**OPEN TENDER ENQUIRY FOR ELEVATORS FOR 1X 800 MW GSECL WANAKBORI
STPP, UNIT No. 8**

CORRIGENDUM/ ADDENDUM- 9

AMENDMENT-02 TO TECHNICAL SPECIFICATION FOR ELEVATOR
(SPEC NO. PE-TS-408-502-A001)

CORRIGENDUM/ ADDENDUM – 09
ADDITIONAL REQUIREMENT OF ELEVATOR.

SPACE FOR MILL
AREA ELEVATOR

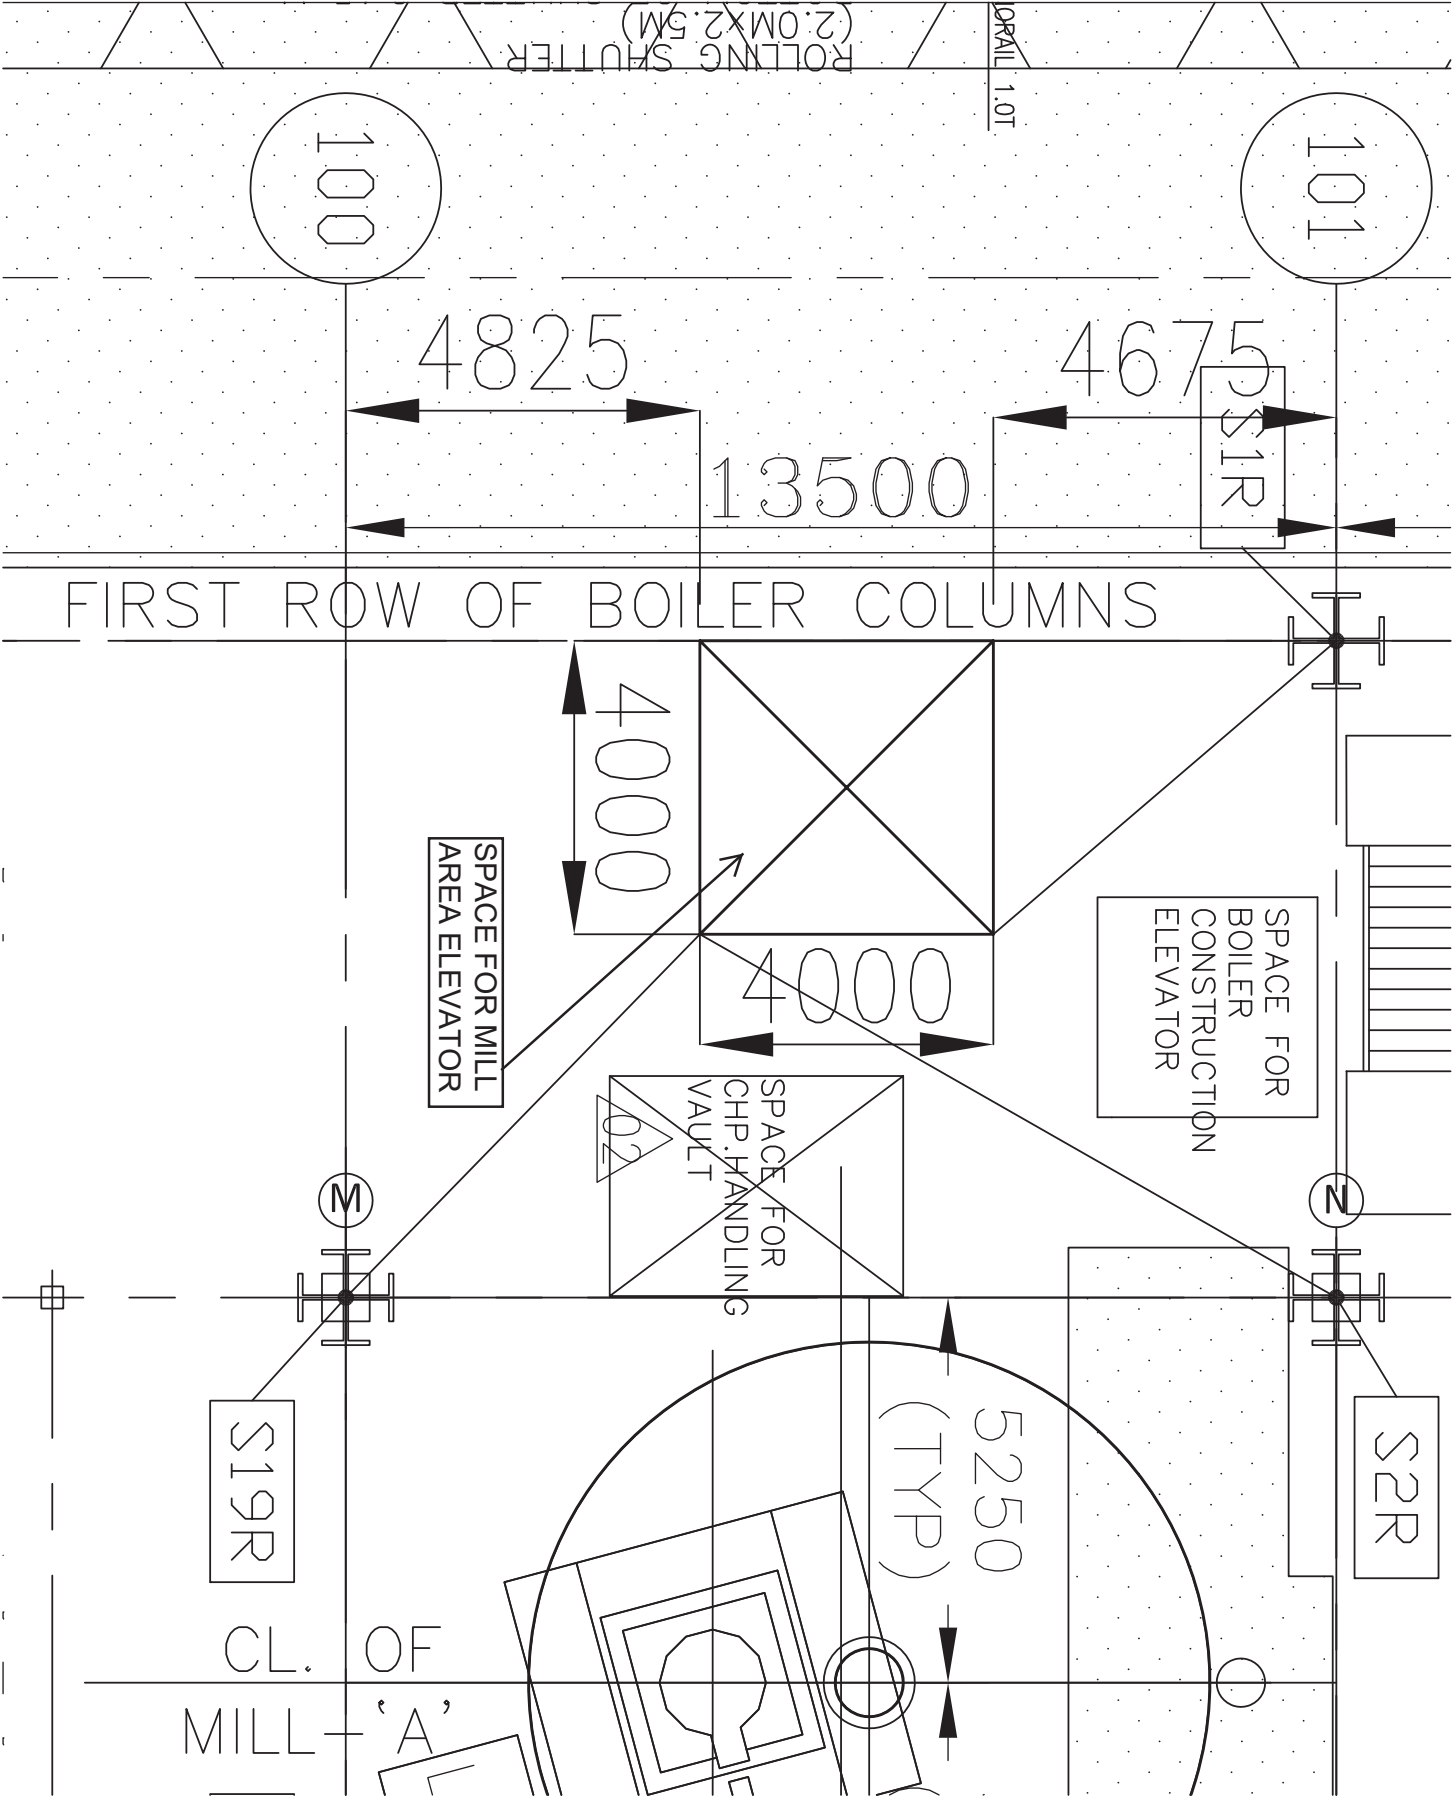
Under above clause of technical specification stipulated at page no. 09 of 204, SECTION-C1 of Vol-II. In addition to the elevators mentioned from sl. no 1 to 2 in table, one more elevator has been added: as follows:

Sl. no	Building	No. of elevators	Capacity	No. of landings	Total rise	Type	Speed
3	Mill Area	1 No.	2000 Kg	<i>Ground + Eight (8). Main landings at 0.0 m, 4.11 m, 22.75 m, 62.88 m & 73.9 m Last landing & Dummy landing at 12.0 m, 32.7 m, 44.10 m & 56.30 m</i>	73.9 M	Conventional Type (Goods cum passenger elevator)	0.5 M/s

Details of Elevator shaft well dimension as per layout is 4000 mm x 4000 mm is tabulated below. For location a sketch is attached with this annexure.
